Title: TOP & POWER

Project: NU			
Size: A4	Reference: MB1136	Revision: C.3	
Date: 9/26/2014		Sheet: 1 of 4	life.augmented

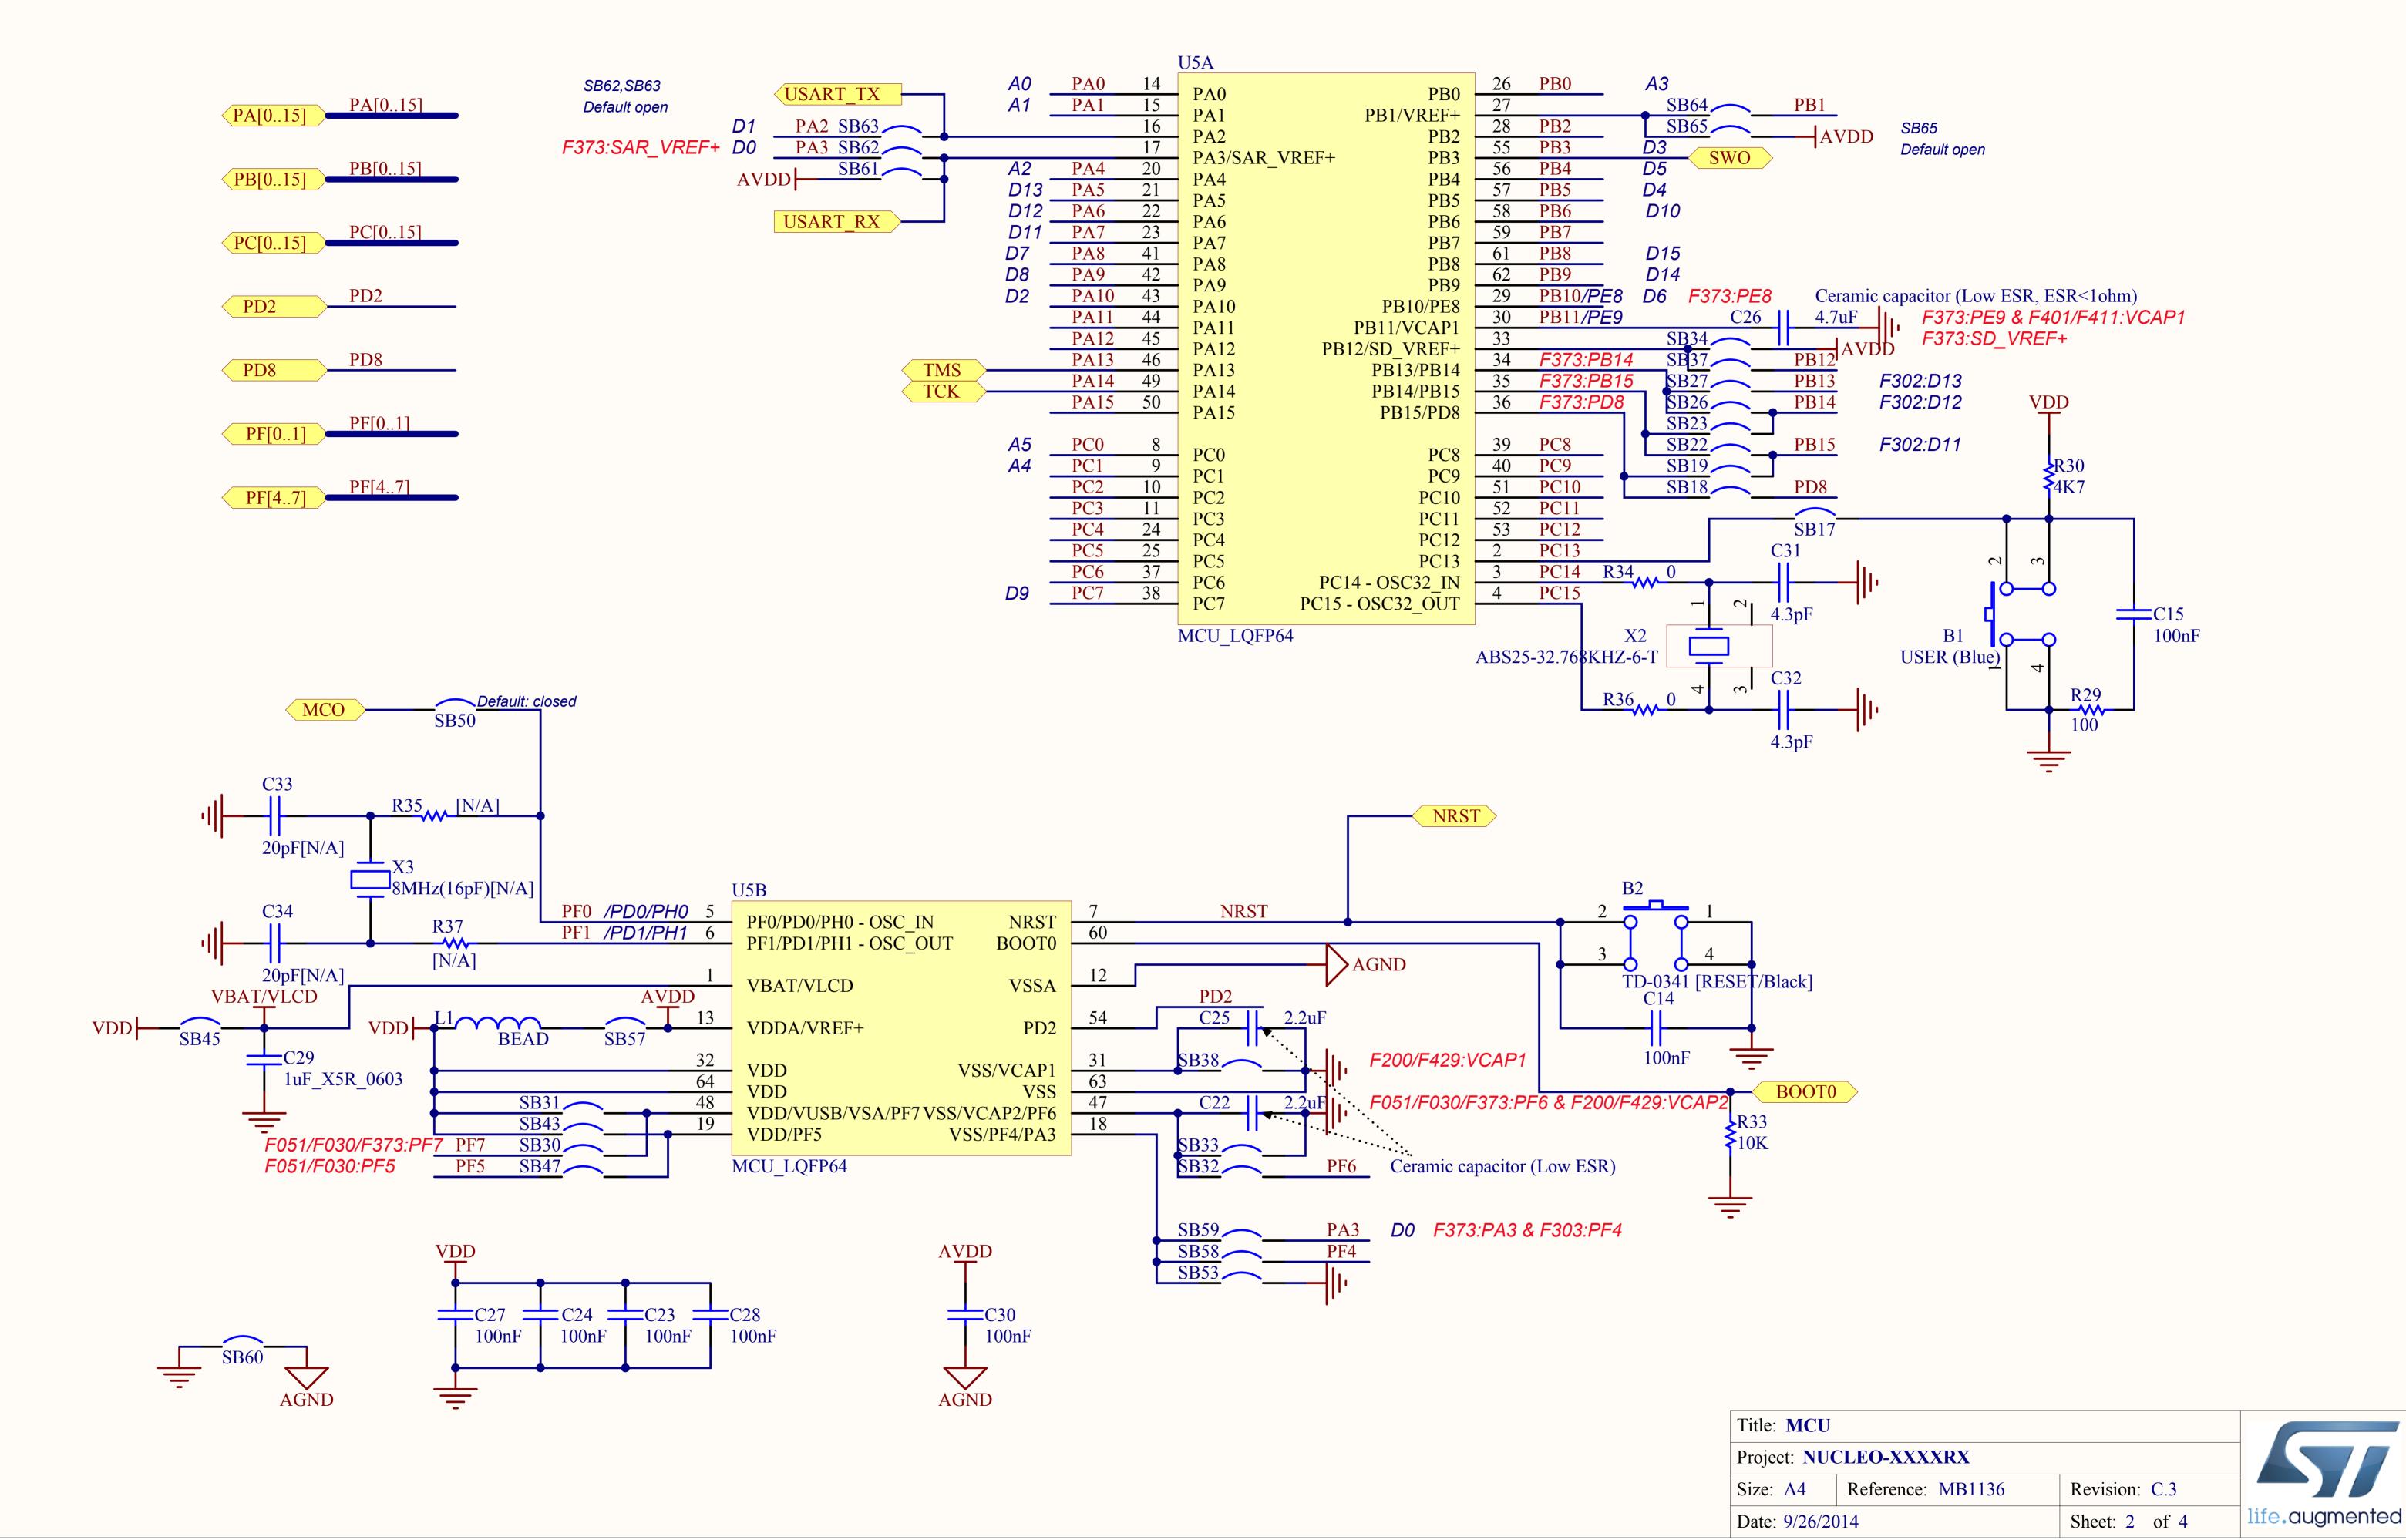
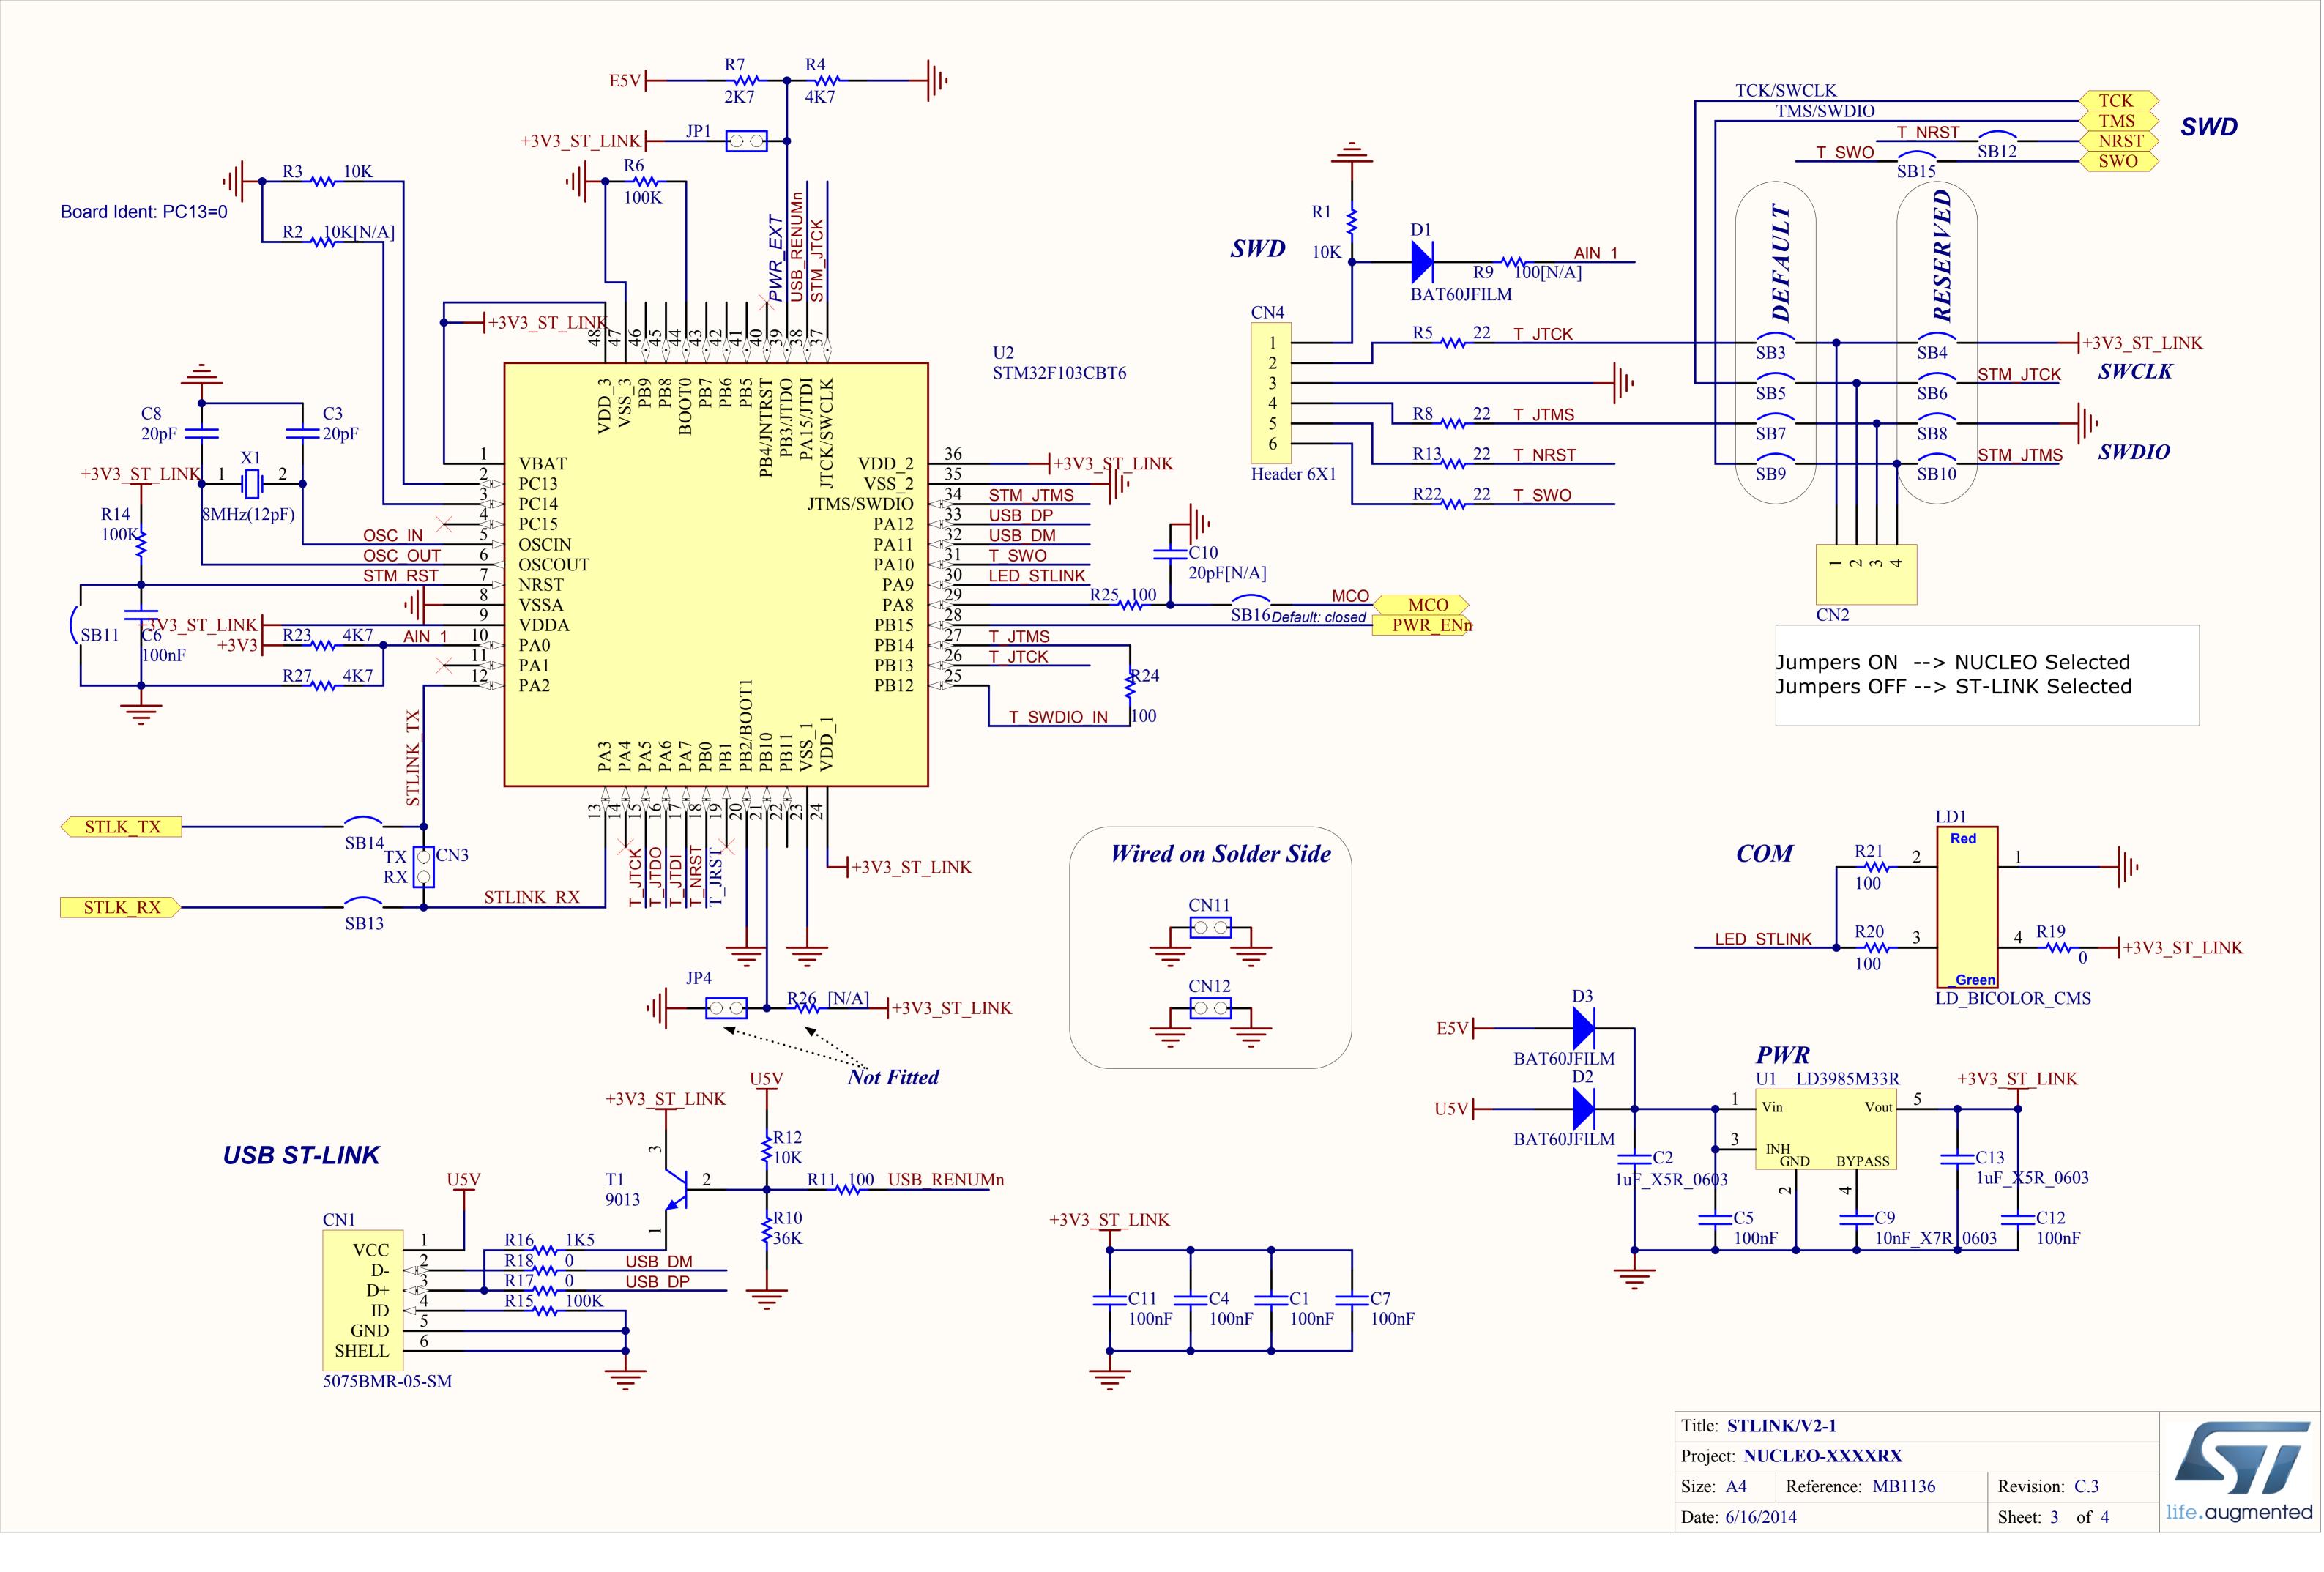
Note2: Remove [N/A] on R34, R36, C31, C32, X2 from C.1 to C.2

Note3: Add "default open" on SB48, SB49, SB55 from C.1 to C.2

Note4: Replace "default open" by "default closed" on SB16 & SB50 from C.1 to C.2

Note5: C31&C32 value changed from 10pF to 4.3pF to fit with new 32K crystal ABS25-32.768KHZ-6-T
